# UPDATES

## Spitfire Mk IX & XVI engineered ISBN: 978-0-9784001-0-1

**Errata July 2008** for book: **Spitfire Mk. IX & XVI engineered** 1st edition, 1st printing.

Elevator tip, additional dimensions  
to control tip curvature

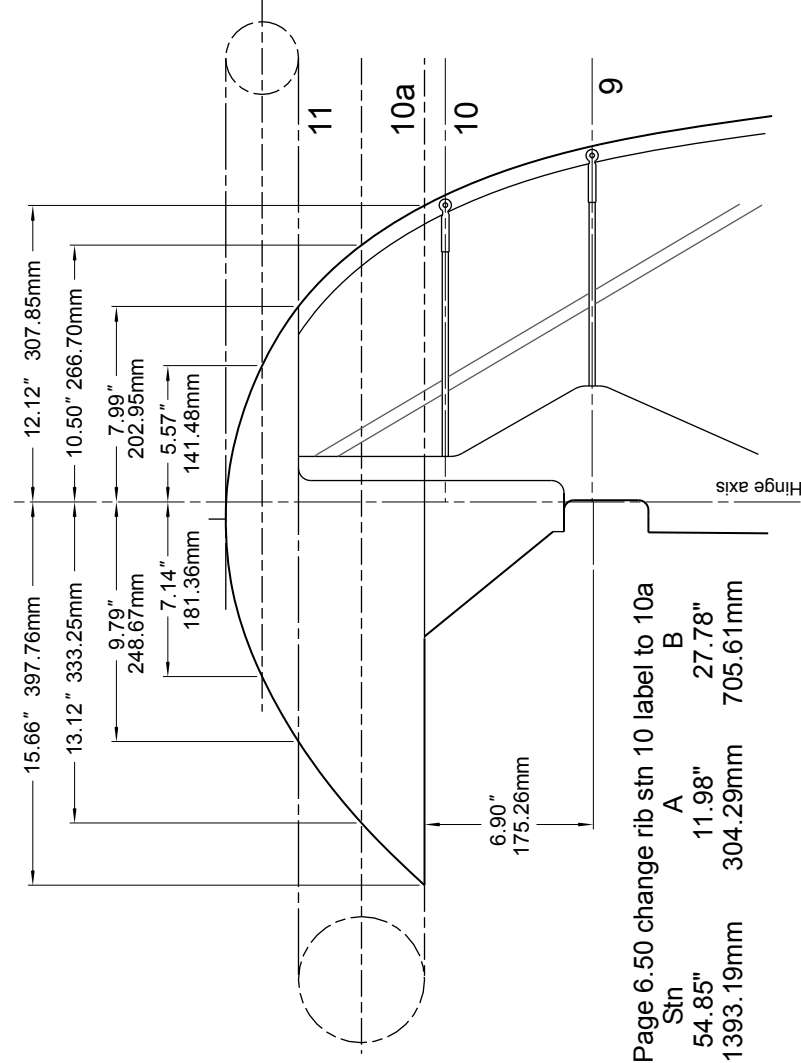
Elevator horn balance for early production Mk. IX
